# LANDSCAPE & TREES

# LANDSCAPE & TREES

# Incompetent Landscape Impact Assessment

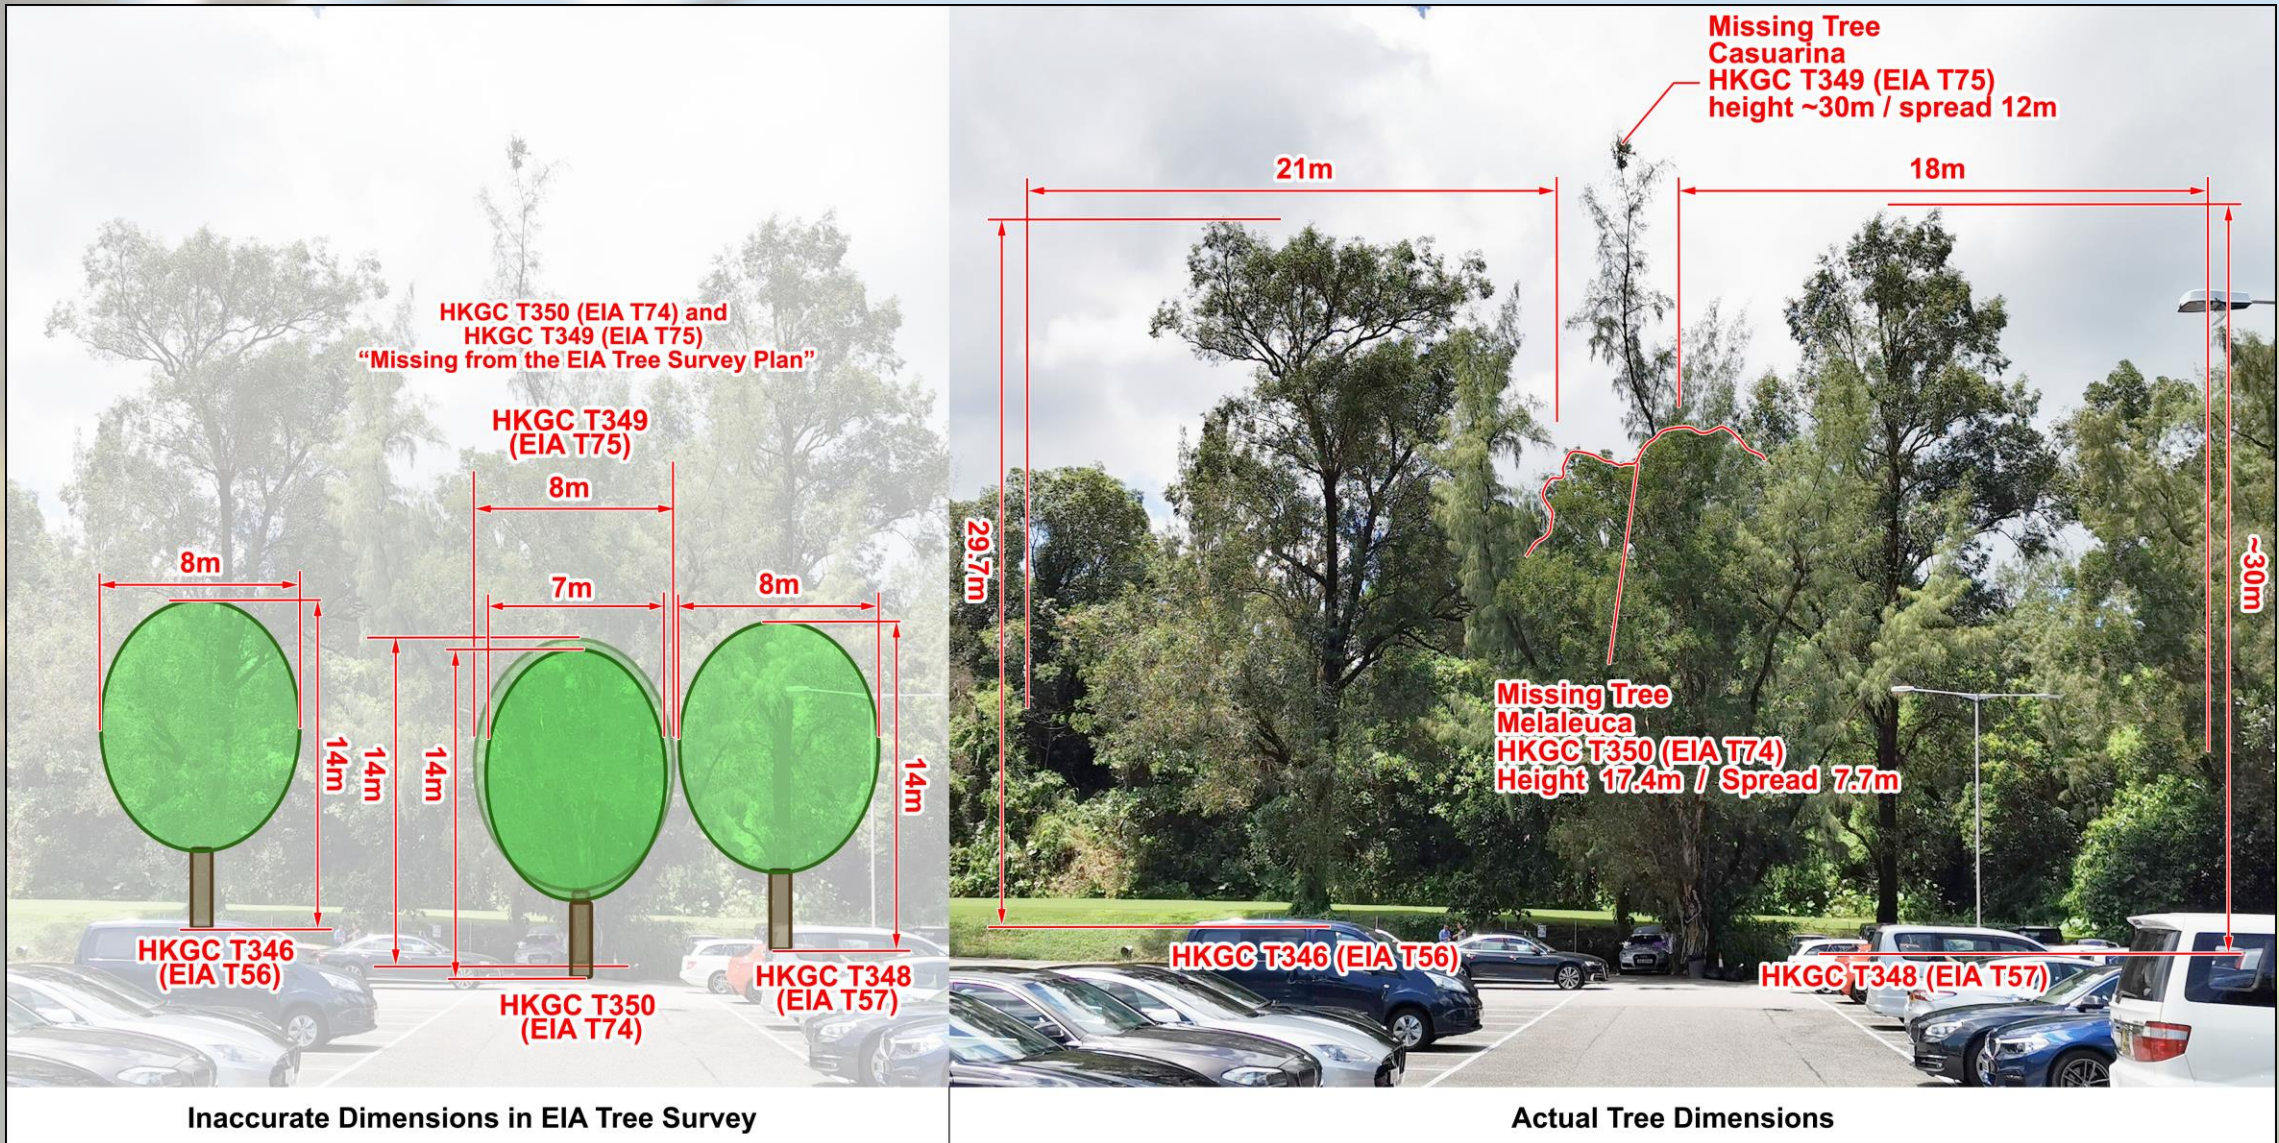
- Tree diameter at breast height (DBH) is under-measured by average **86%** and to as low as **23%** of DBH
- Tree height is under-measured by average **76%** and to as low as **29%** of actual height
- Tree canopy spread is under-measured by average **60%** and to as low as **25%** of actual canopy spread in open areas and by average **66%** and to as low as **11%** of actual canopy spread in woodland areas
- All the above errors have substantive impact on identification of large Trees of Particular Interest (TPIs) and also the dimensions of their Tree Protection Zones (TPZs).

EIA identified 24 Large TPIs in Sub Area 1 whereas the correct number is **33 Large TPIs (+37% error)**

These highly significant errors have been pointed out to Government (June 2022 (draft review) & May 2023 (detailed review)) but ignored, and continue to be ignored in TPB Paper 10902 as if it doesn't matter.

## Inaccurate Mapping of Landscape Resources

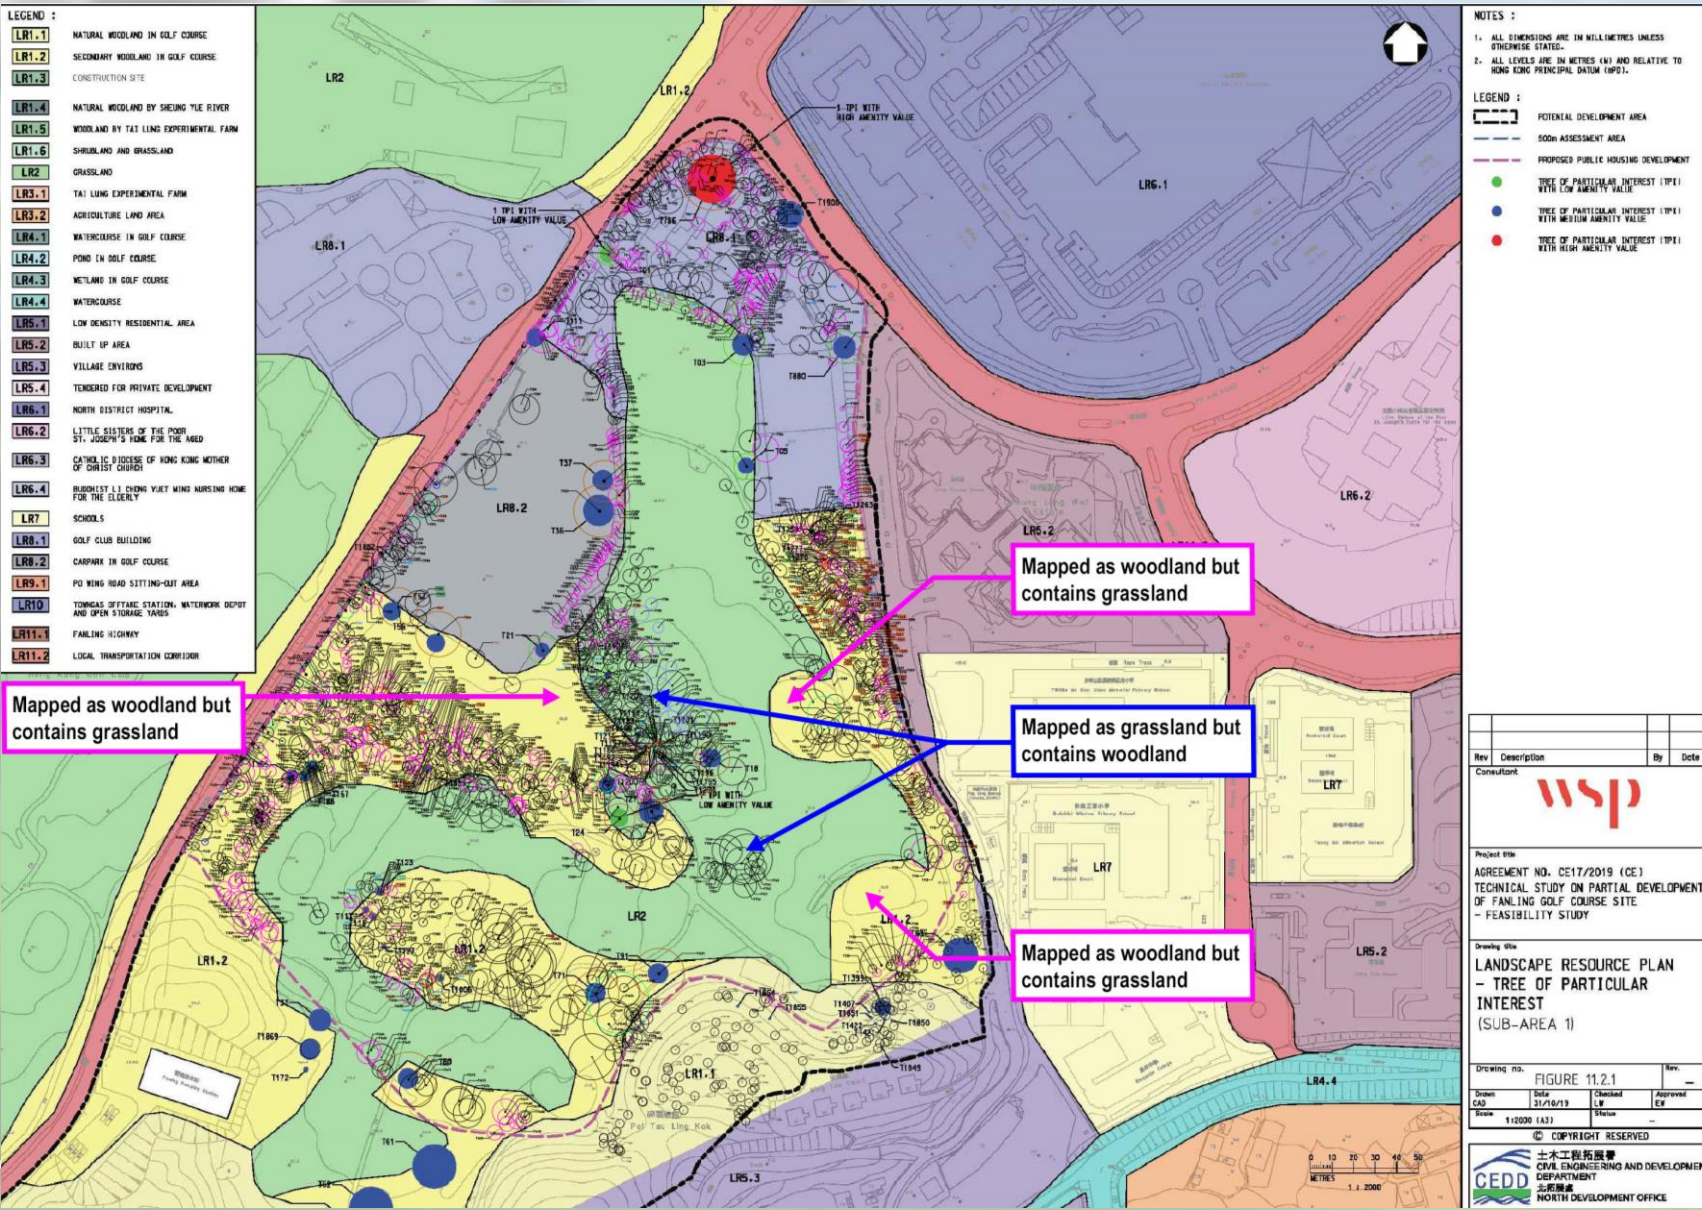
- This diagram shows an overlay of the EIA Tree Survey on the LVIA Plan mapping the landscape resources, colour coded green for Grassland and yellow for Woodland.
- However, the overlay reveals that large areas mapped as grassland are actually woodland, and large areas mapped as woodland are actually grassland!
- Landscape Resources are poorly mapped leading to inaccurate measurement of affected areas of woodland and grassland leading to subsequent inaccurate evaluation of impacts.
- **The assessment cannot be trusted.**

## Inaccurate Mapping of Landscape Resources

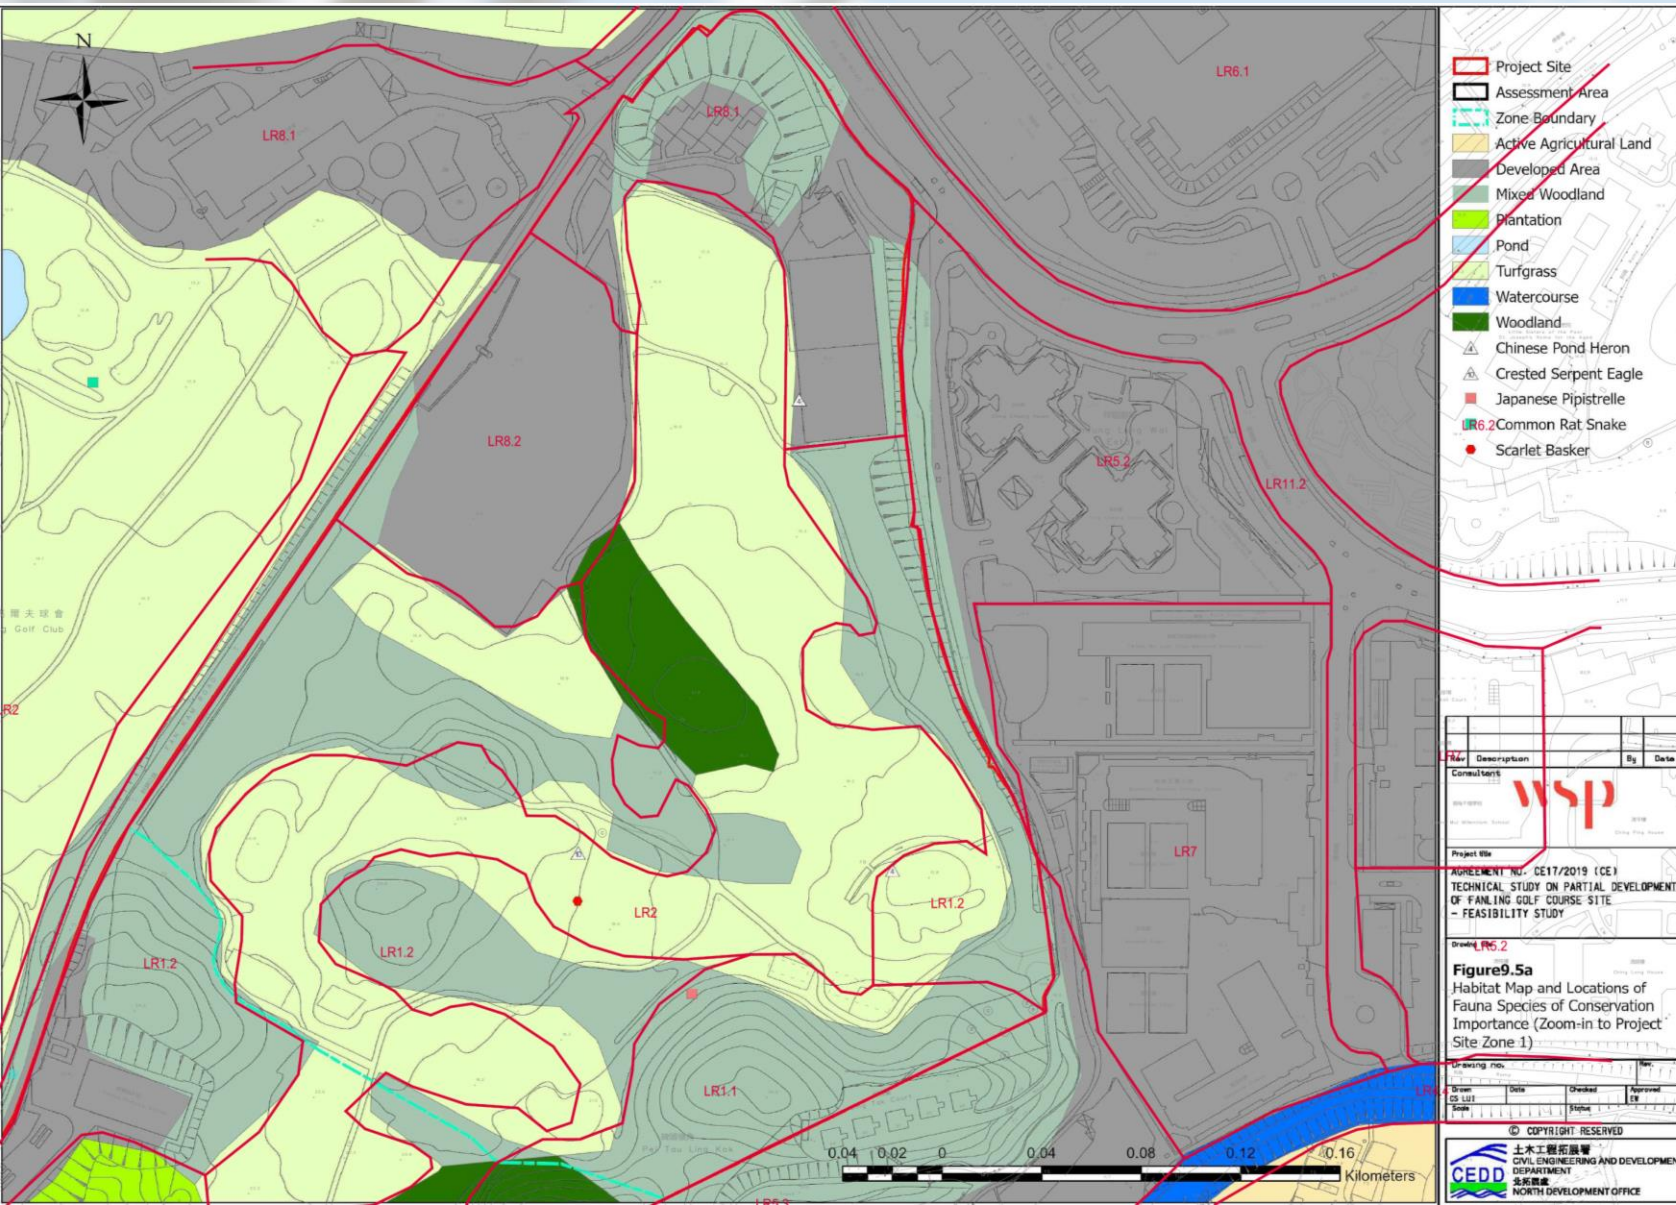
- This diagram shows the Landscape Resource mapping boundaries (red lines) from the plan I just showed you, overlain onto the map of the Ecology Resources in the Ecological Impact Assessment.
- Not only are the boundaries different between the Landscape & Ecological assessments, but so are the descriptions.
- The LVIA identifies ‘Natural Woodland’ and ‘Secondary Woodland’ and the EcoIA identifies ‘Woodland’ and ‘Mixed Woodland’ - and with totally different geographical distributions that do not correlate.
- **The assessment cannot be trusted.**

## Highly Impractical Transplanting Proposal

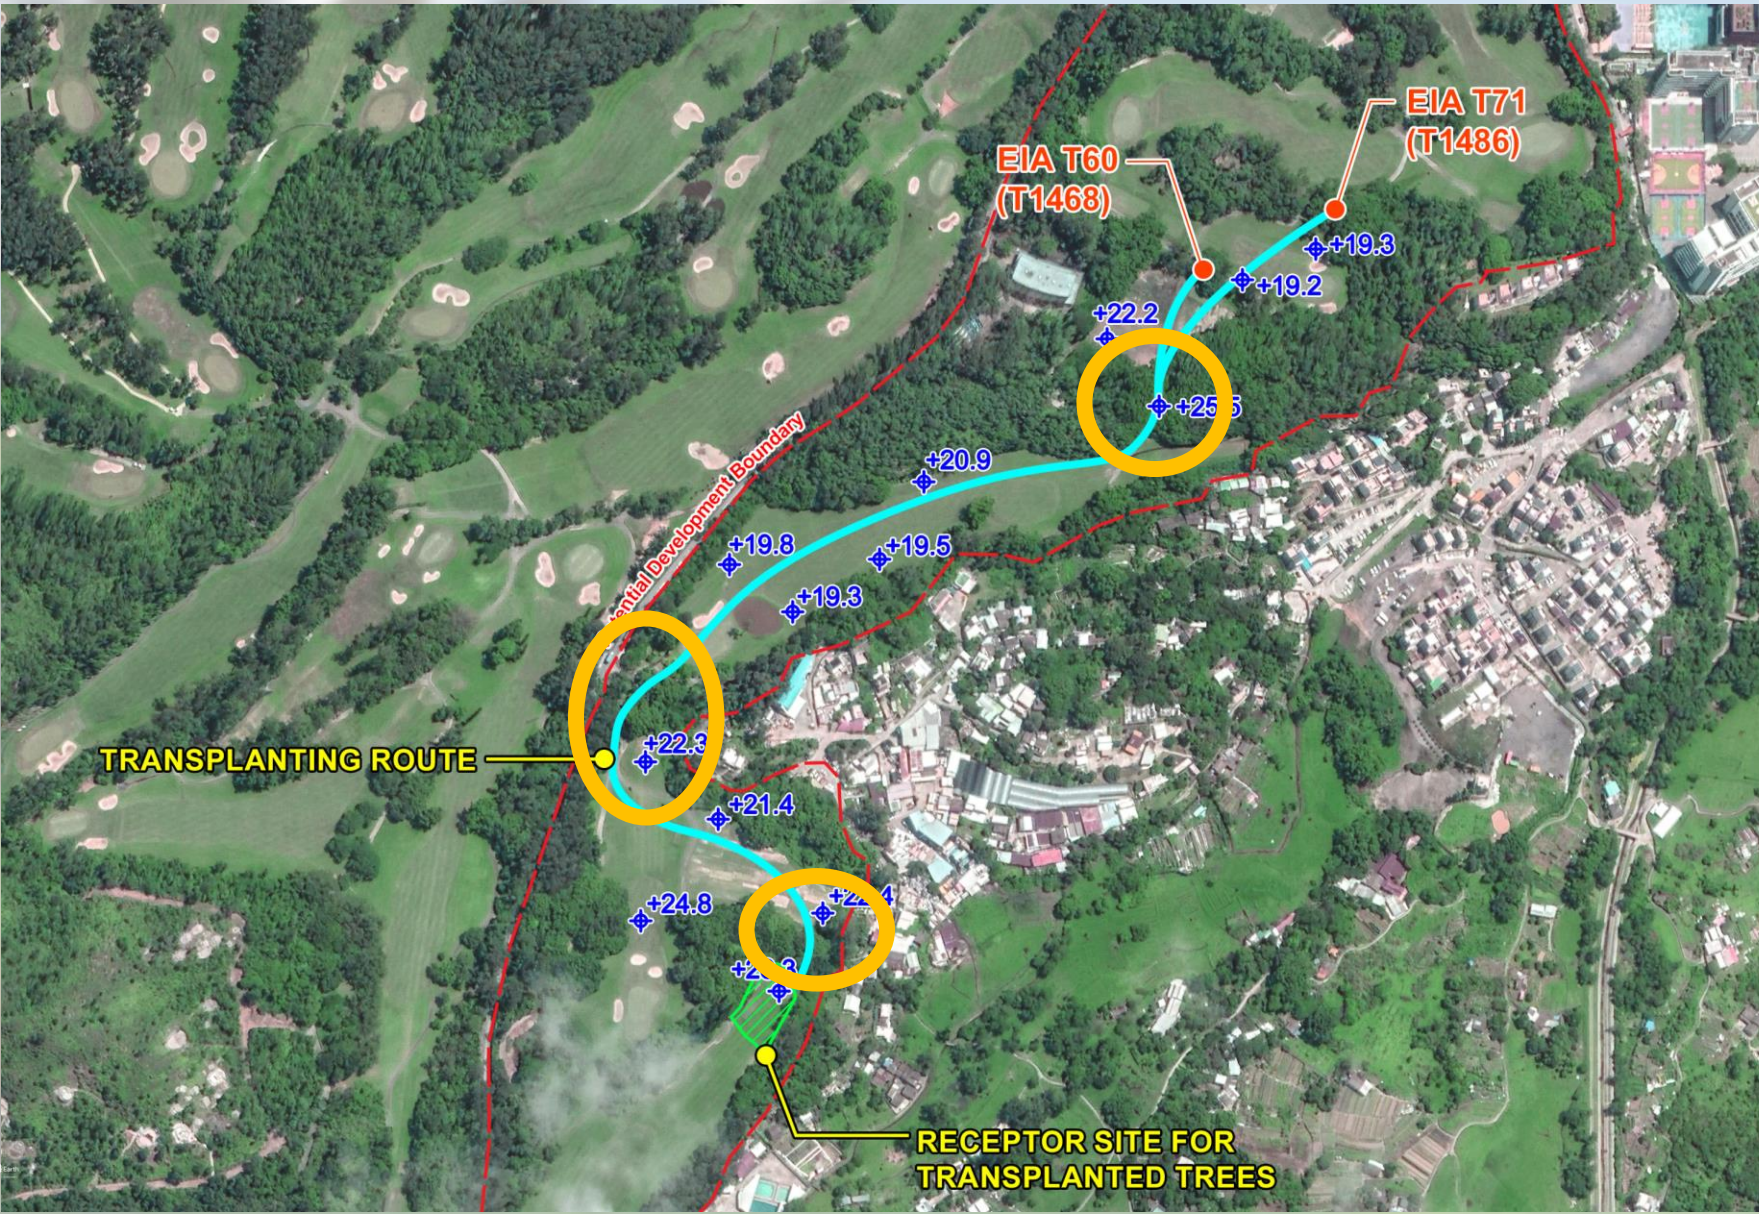
- EIA proposes to transplant a number of trees including 2 large TPIs (pOVTs).
- Transplanting of these large trees is not impossible, although it is a major engineering exercise, involving the creation of very large and deep rootballs.
- However, transplanting of OVTs goes against the recommendations in DEVB TC(W) 5/2020

Table 11.11 - Significance Threshold for LR & LCA

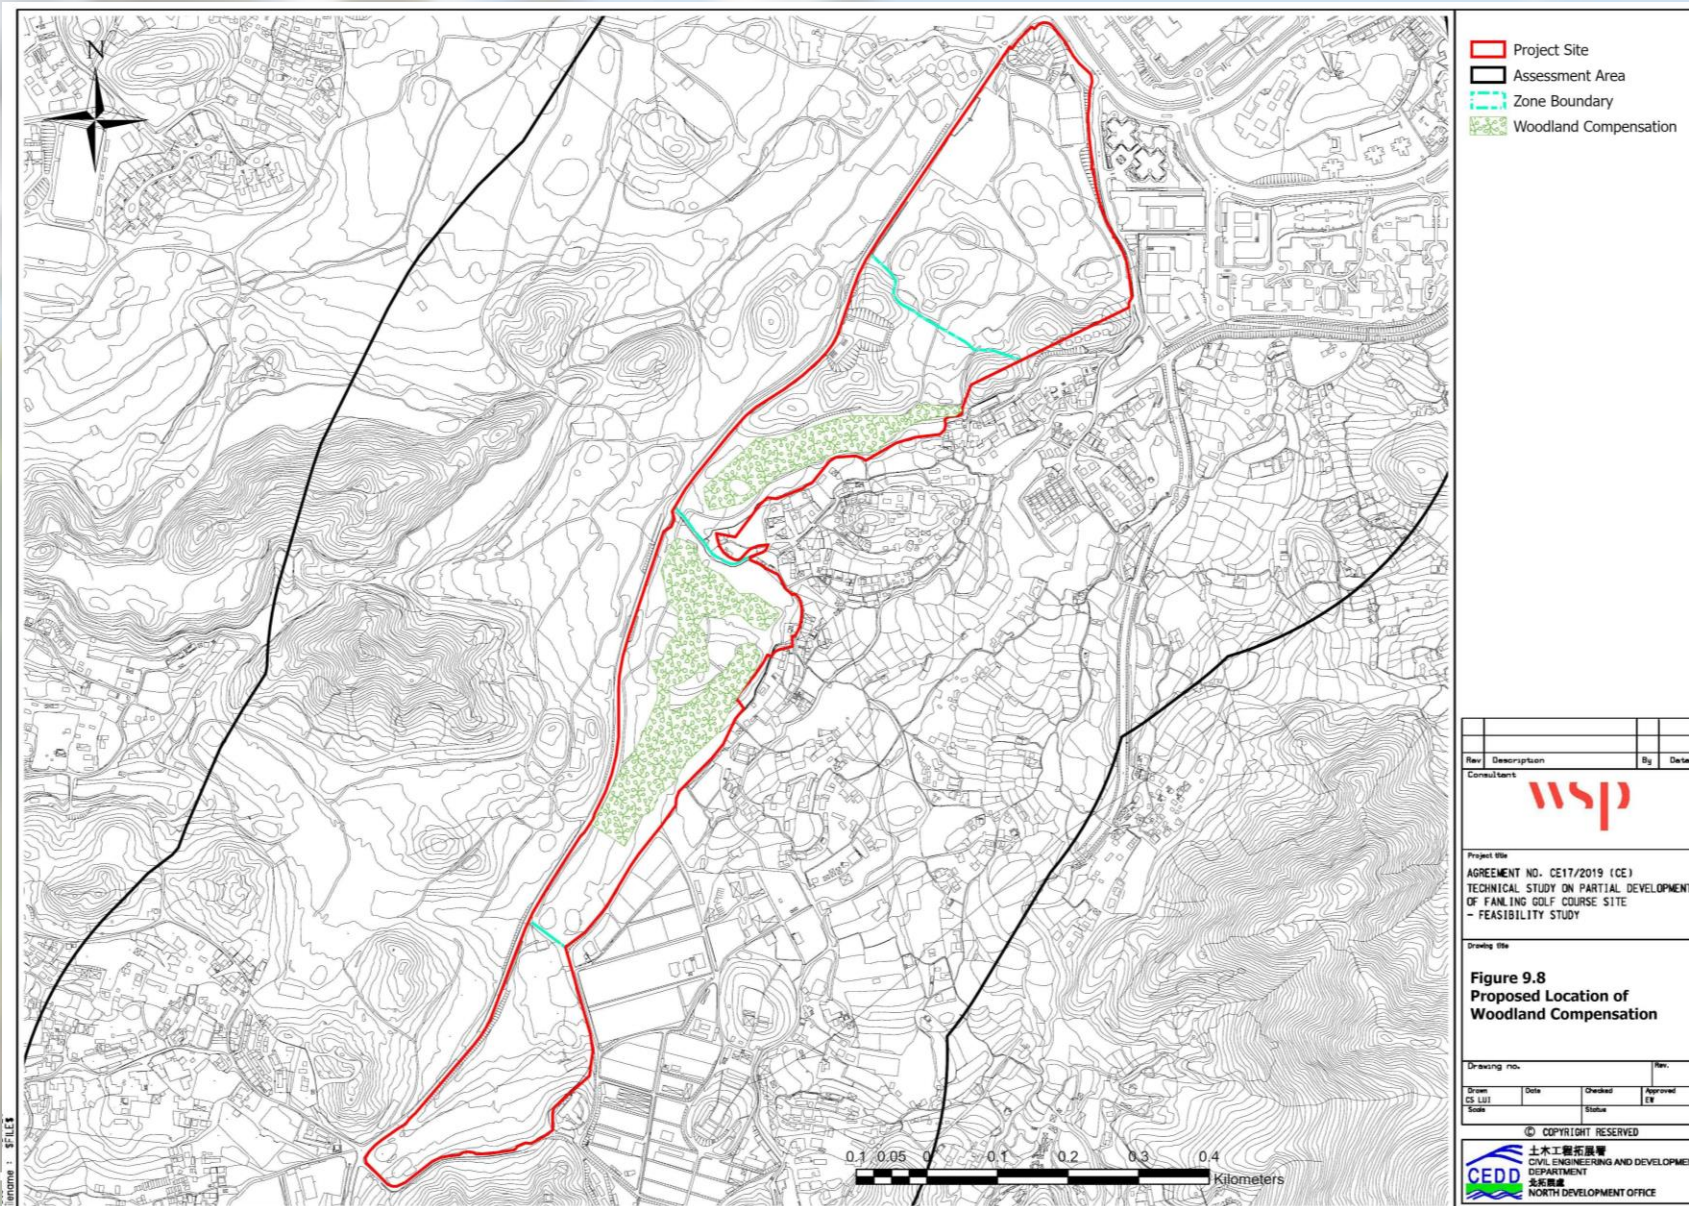
- EIA Table 11.10 lists the Mitigation Measures that supposedly will reduce the degree of impact on landscape resources and landscape character areas to acceptable levels.
- None of the MMs listed to mitigate impacts on Grassland have any relevance.
- “OM4 - Compensatory Tree Planting” will actually destroy more Grassland in Sub Areas 2&3, more than trebling the adverse impacts on Grassland!
- The assessment cannot be trusted.
